**N O R T H F A L L S**

# **Outline Construction Traffic Management Plan ~~(Clean)~~(Tracked)**

Document Reference: 7.16  
Volume: 7  
Date: July 2025  
Revision: 45

Project	North Falls Offshore Wind Farm
Document Title	Outline Construction Traffic Management Plan (Clean)(Tracked)
Document Reference	7.16
Supplier	Royal HaskoningDHV
Supplier Document ID	PB9244-RHD-ES-ON-RP-ON-0181

Drawing 104560-MMD-00-XX-DR-CE-1061\_Rev01

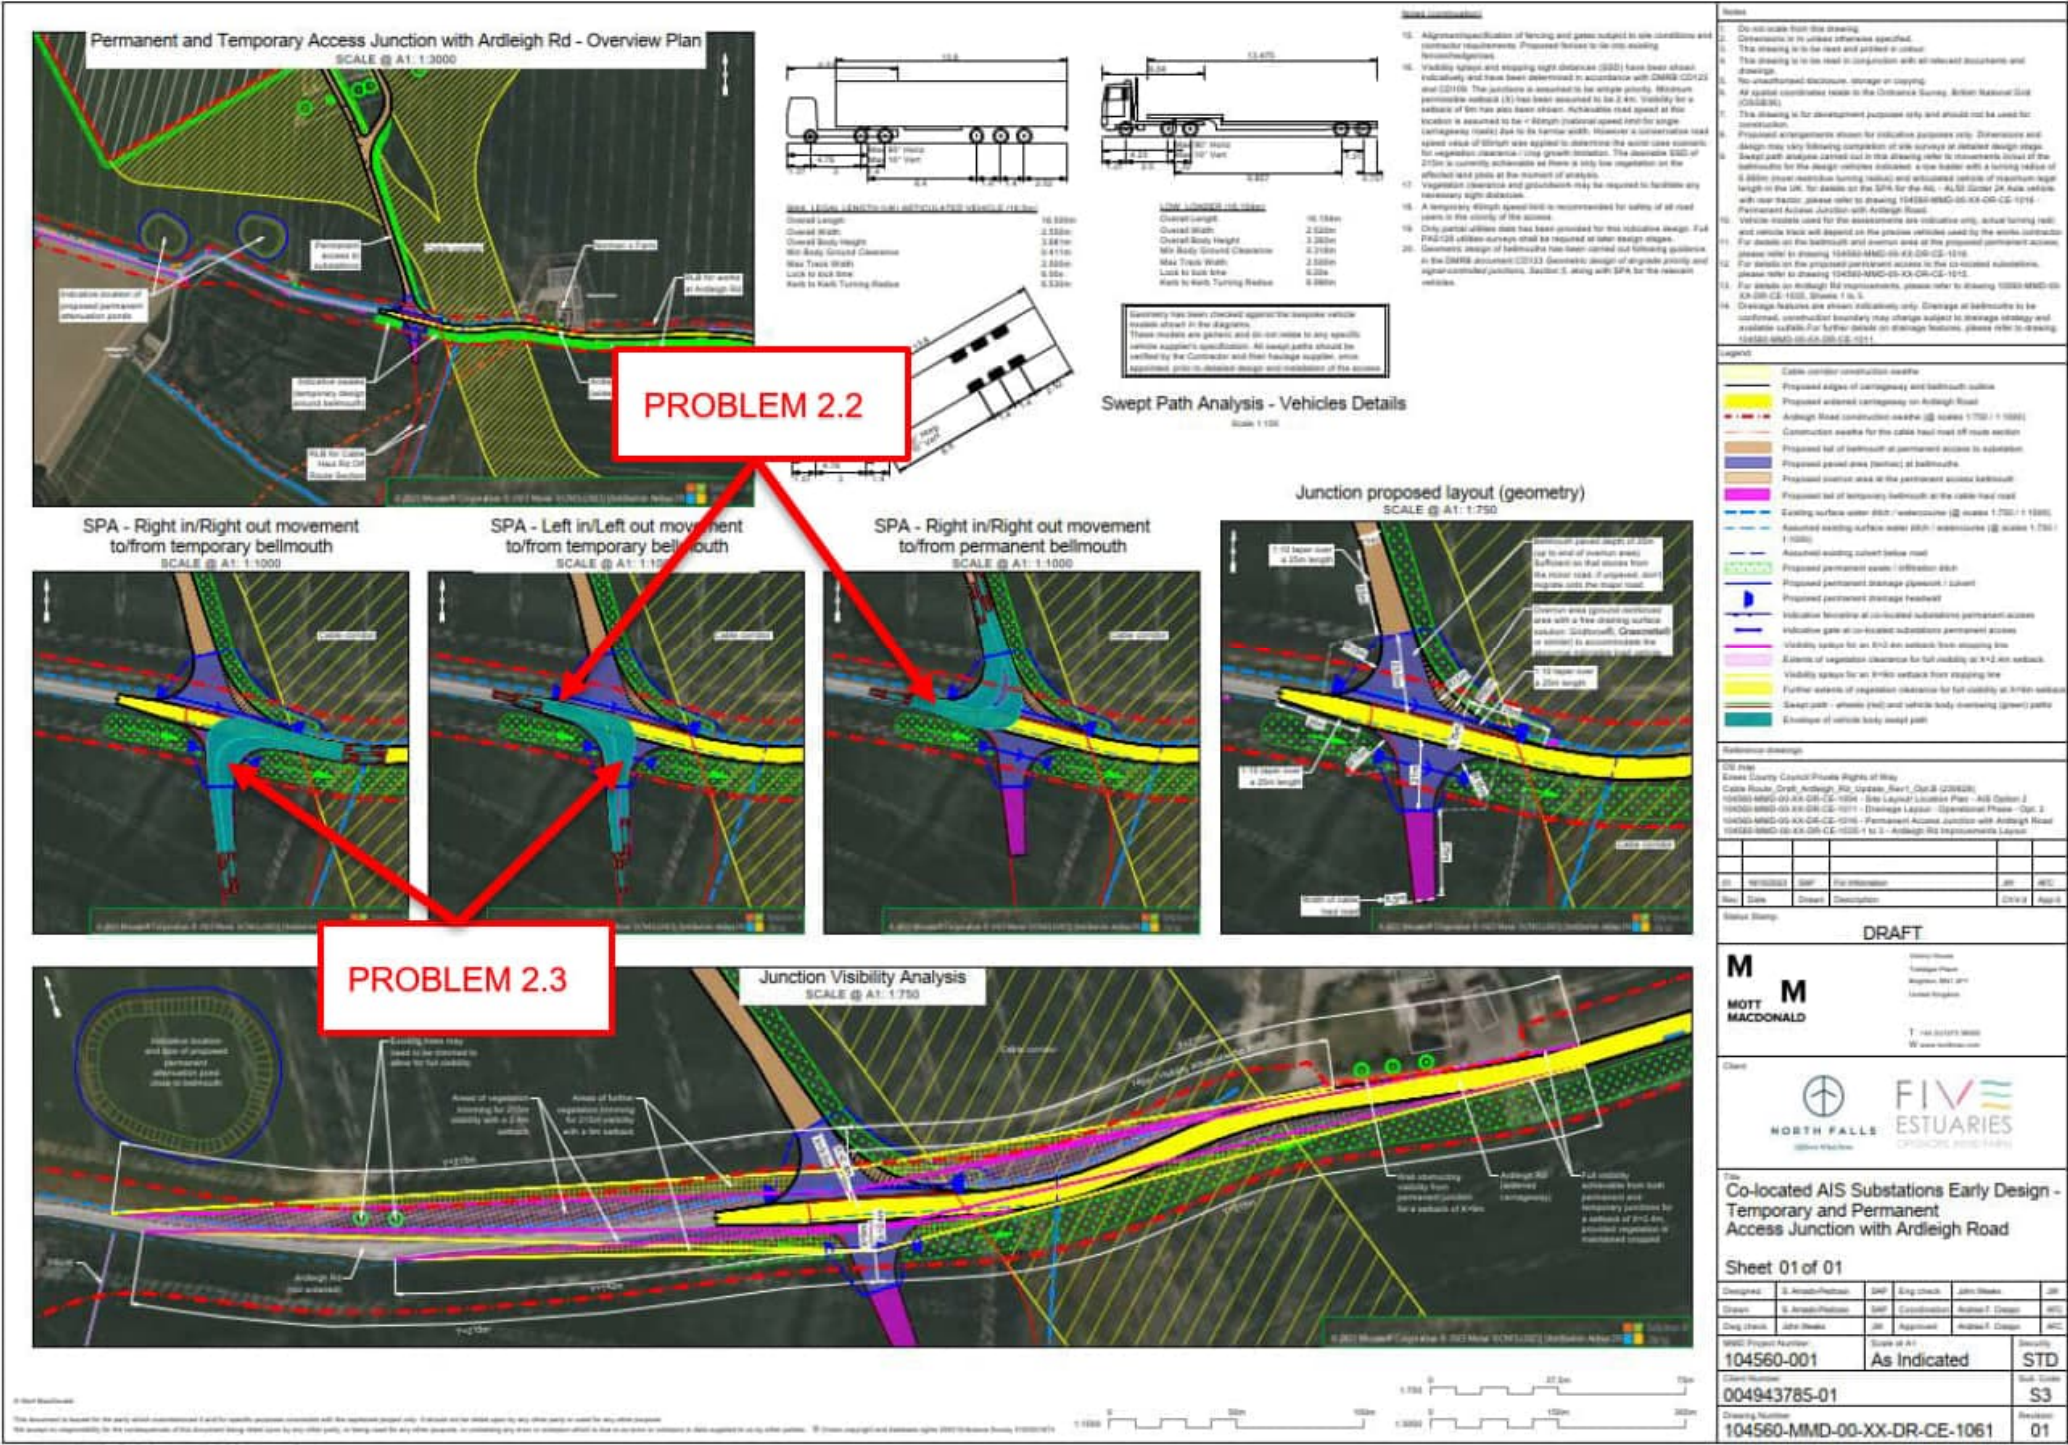
Drawing 104560-MMD-00-XX-DR-CE-1061_Rev01						
2.1	<p>Location: Site Access (Temporary Access Junction with Ardleigh Rd)</p> <p>Summary: Overhead cables may lead to damage to infrastructure, vehicles and occupants.</p> <p>Onsite observations noted the presence of overhead cables that cross Ardleigh Road in various locations in the vicinity of the proposed development.</p> <p>The vertical alignment of proposed HGV access movements may lead to damage to infrastructure or damage to vehicles and injury to occupants.</p>	<p>It is recommended that the vertical assessment is carried out for the appropriate vehicle types to ensure no conflict remains.</p>	<ul style="list-style-type: none"><li>● RSA problem and recommendation agreed.</li><li>● This matter will be appraised further as an integral part of the detailed design process, when full PAS128 utilities surveys are to be obtained, and drawings detailing diversion or undergrounding (and/or further measures required) of utilities in the vicinity of the proposed access junction and crossing will be developed to take due account of the safety problem and the aligned recommendation.</li><li>● A wider utility diversion / undergrounding assessment would need to be carried out by the third party in charge of the Ardleigh Rd improvement works design at the scheme detailed design stage, when full PAS128 utilities surveys shall be completed. Coordination between Mott MacDonald and that third party may be required.</li><li>● Notes 9 and 19 in drawing 104560-MMD-00-XX-DR-CE-1061_Rev01 are intended to account for this matter:</li><li>● Note 9. «Proposed arrangements shown for indicative purposes only. Dimensions and design may vary following completion of site surveys at detailed design stage».</li><li>● Note 19. «Only partial utilities data has been provided for this indicative design. Full PAS128 utilities surveys shall be required at later design stages».</li></ul>	TBC	TBC	<p>This matter will be appraised further as an integral part of the detailed design process, when full PAS128 utilities surveys are to be obtained, and drawings detailing diversion or undergrounding of utilities in the vicinity of the proposed access junction and crossing will be developed to take due account of the safety problem and the aligned recommendation (TBC).</p>

Drawing 104560-MMD-00-XX-DR-CE-1032-1\_Rev02

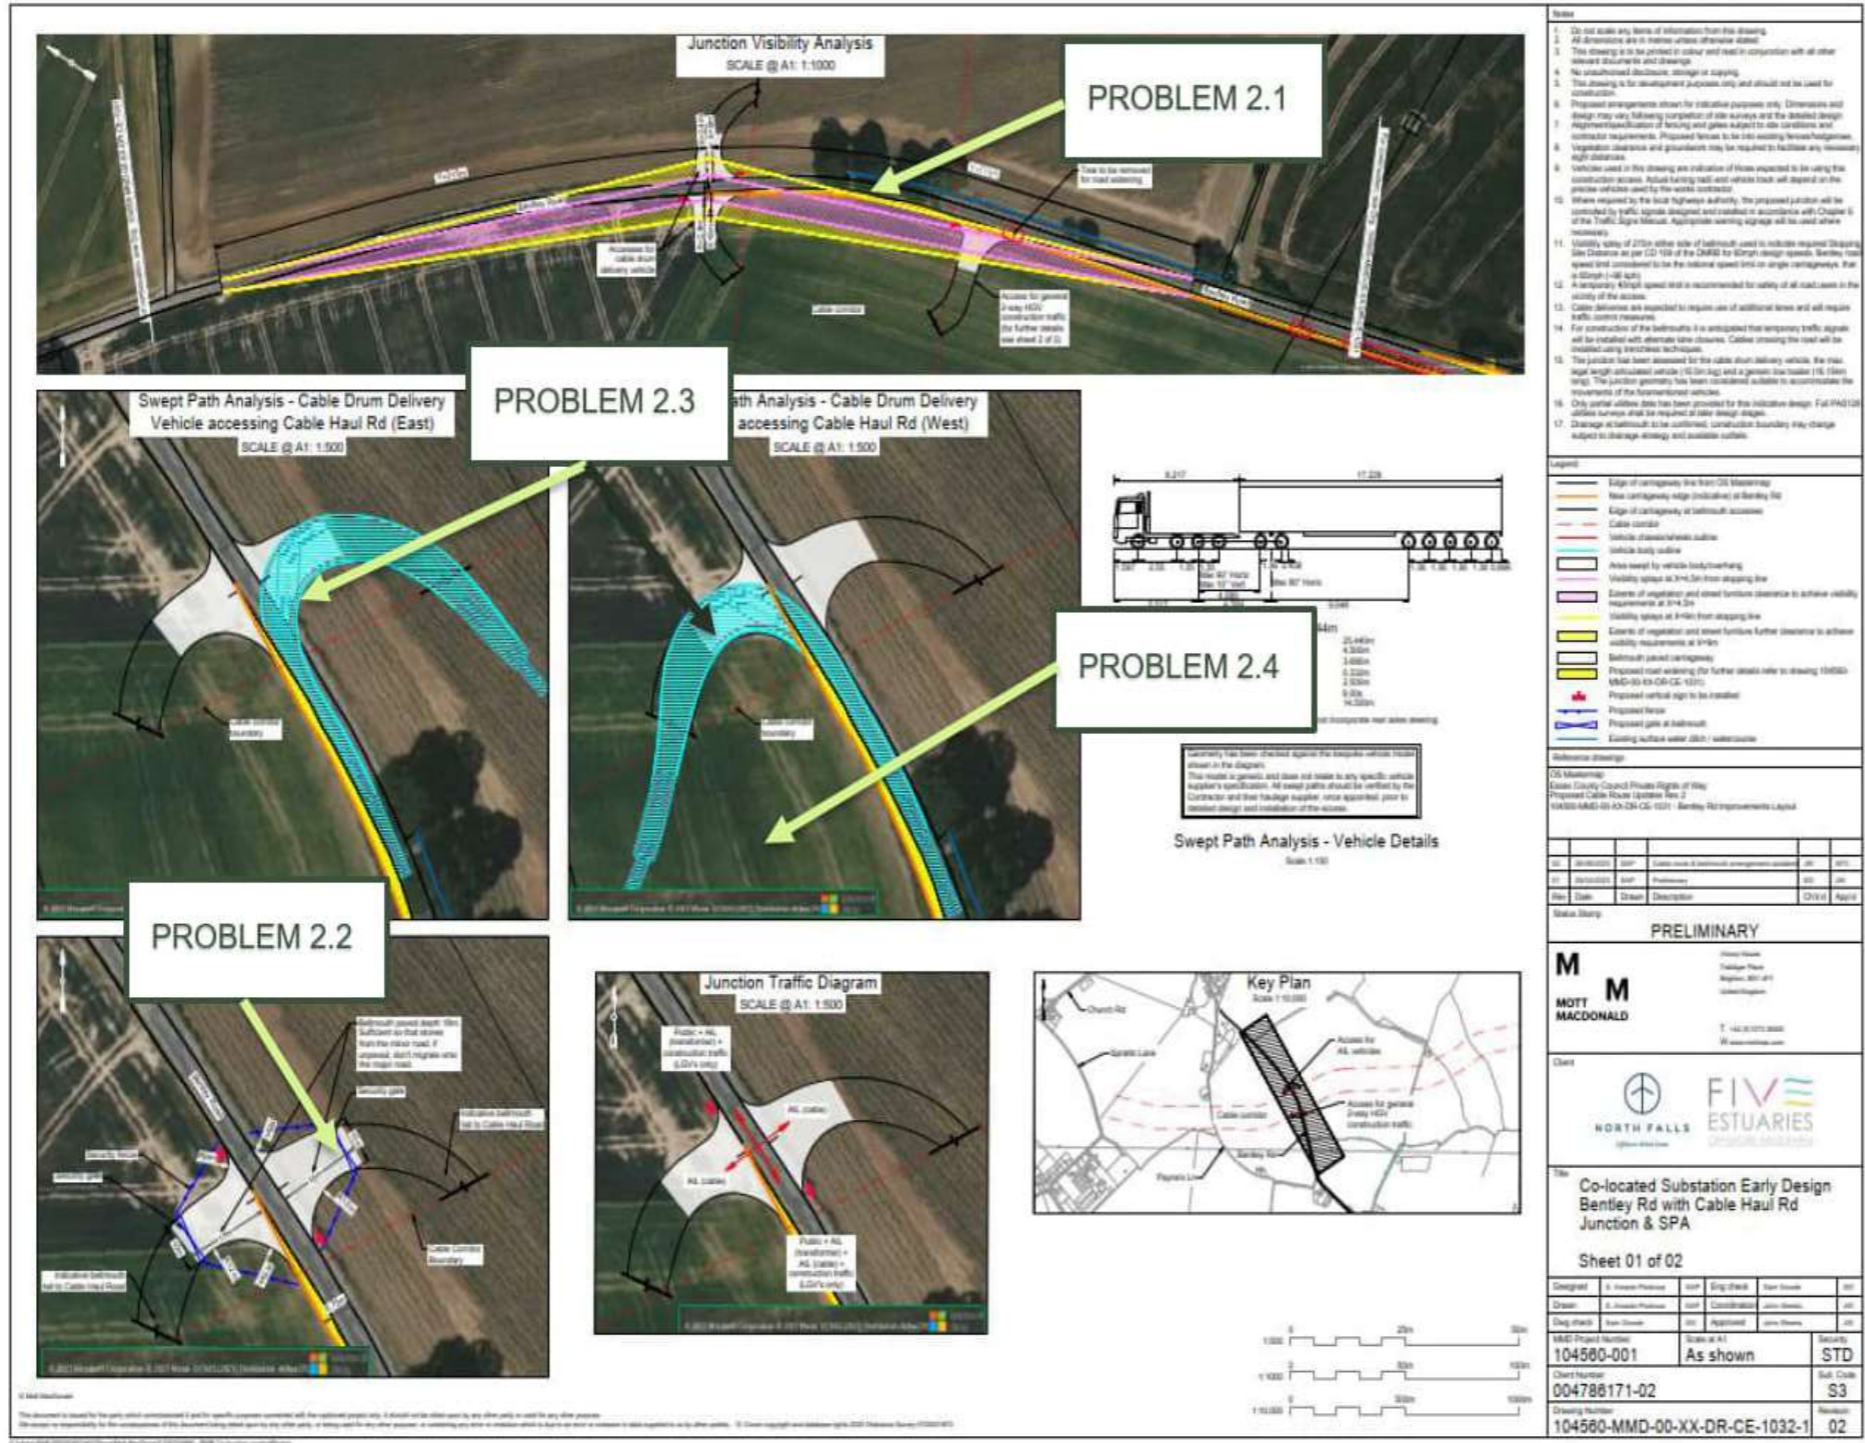
Drawing 104560-MMD-00-XX-DR-CE-1032-1_Rev02						
2.1	<p>Location: Site Access (Temporary Access Junction with Bentley Rd). Refer to Appendix B.</p> <p>Summary: At a 9m setback, existing trees may obscure the visibility splay potentially leading to side swipe type collisions.</p> <p>Onsite observations noted that the presence of existing vegetation may constitute an obstruction to the junction visibility. Obstruction to visibility splays may lead to injudicious vehicle movements at the proposed junction leading to side swipe collisions between vehicles.</p>	<p>It is recommended that the trees be cut back and maintained as such that it does not pose an obstruction to the visibility splays.</p>	<ul style="list-style-type: none"><li>● RSA problem and recommendation acknowledged but not agreed since it is not considered that these trees have an impact on the visibility clearance areas. The visibility splay with a 9m setback on the eastern side of Bentley Rd (northern side of Bentley Rd on drawing 104560-MMD-00-XX-DR-CE-1032-1) only captures a small area of road verge west of these existing trees, to run across the road to the other verge side west of Bentley Rd (South of Bentley Rd in drawing 104560-MMD-00-XX-DR-CE-1032-1). Cutting back or trimming the trees will not produce any changes to visibility. Trees are located on the southeast of the road and will cast shadow during most part of the day unless they are totally cut.</li><li>● In drawing 104560-MMD-00-XX-DR-CE-1031-3 for the same scheme (refer to Appendix C in this document), it is indicated the trimming of these existing trees to facilitate passage of vehicles, which will also help with general visibility.</li><li>● No designer action proposed.</li></ul>	TBC	TBC	No action (TBC).

Drawing 104560-MMD-00-XX-DR-CE-1032-2_Rev01						
2.5	<p>Location: Proposed site access. Refer to Appendix B.</p> <p>Summary: The level difference between the carriageway and site could result in loss of control or side swipe type collisions.</p> <p>Onsite observations found that there was a difference in levels between the existing carriageway and the new access. An excessive gradient may create difficulty for large construction vehicles wishing to access Lodge Lane and may in turn lead to a lack of surface friction and slow egress movements potentially creating shunt / side swipe type collisions between egressing construction vehicles and vehicles travelling on Bentley Road.</p>	<p>It is recommended that the existing gradient be amended to an appropriate level for the restart movements of large vehicles accessing Bentley Road from the proposed site</p>	<ul style="list-style-type: none"><li>RSA problem and recommendation agreed.</li><li>This matter will be appraised further as an integral part of the detailed design process and drawings developed to take due account of the safety problem and the aligned recommendation.</li></ul>	TBC	TBC	This matter will be appraised further as an integral part of the detailed design process and drawings developed to take due account of the safety problem and the aligned recommendation. (TBC)

Drawing 104560-MMD-00-XX-DR-CE-1066\_Rev03

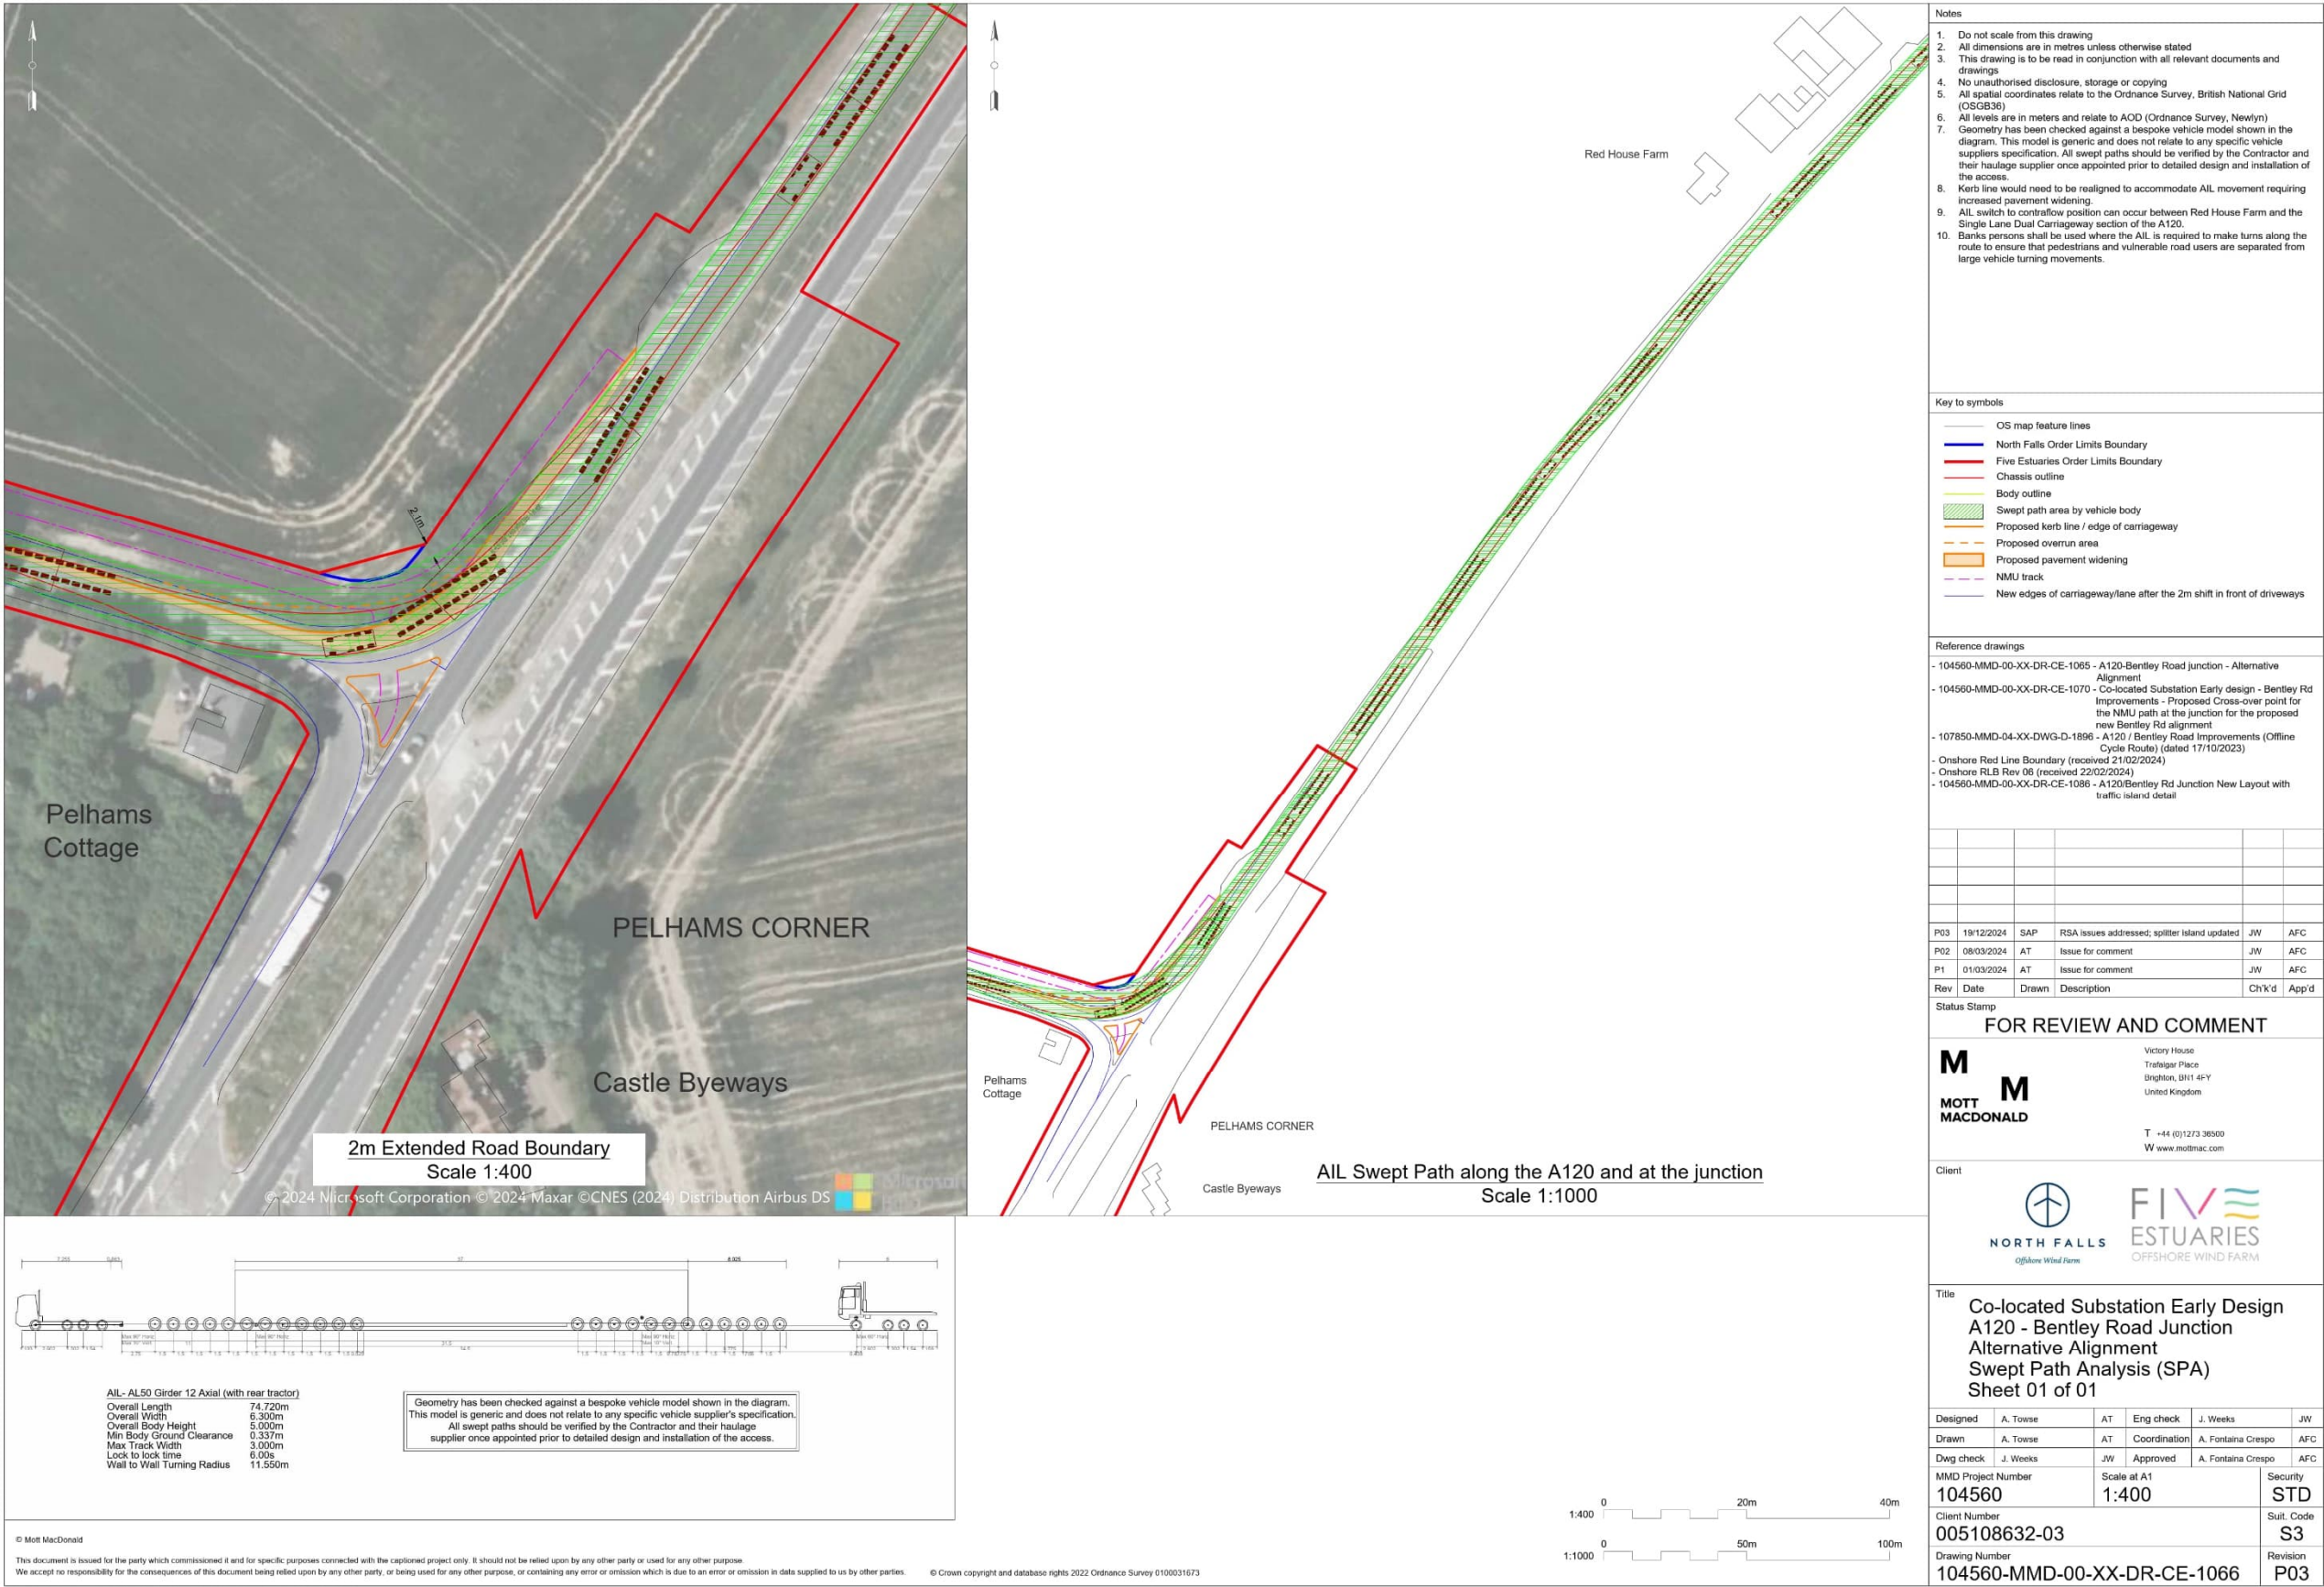
Drawing 104560-MMD-00-XX-DR-CE-1066_Rev02						
2.2	<p>Location: A120/Bentley Rd Junction.</p> <p>Summary: Overrun of Exceptional 74.720m HGV into NMU corridor.</p> <p>Design drawings show swept path analysis of a multi axle drawbar HGV entering Bentley Road from the A120. The analysis drawing indicates that the body of this exceptional HGV will over sail the new NMU route as the vehicle turns from the A120 onto Bentley Road. This</p>	<p>It is recommended that banks persons are used where HGVs are required to make turns along the route to ensure that pedestrians and vulnerable road users are separated from large vehicle turning movements.</p>	<ul style="list-style-type: none"><li>● RSA problem acknowledged and recommendation agreed.</li><li>● The use of banks persons is implicit within the Temporary Traffic Management measures to be agreed with the Local Highways Authority. These TTM measures shall be detailed at a later stage of the project.</li><li>● A note specifying the use of banks persons shall be added to drawing 104560-MMD-00-XX-DR-CE-1066_Rev03 for clarity.</li></ul>	<p>To be populated by the Audit Team</p>	<p>To be populated by the Client / Project Sponsor</p>	<p>A note specifying the use of banks persons shall be added to drawing 104560-MMD-00-XX-DR-CE-1066_Rev03 for clarity.</p> <p>TTM measures shall be detailed and agreed with the LHA at a later stage of the project.</p>
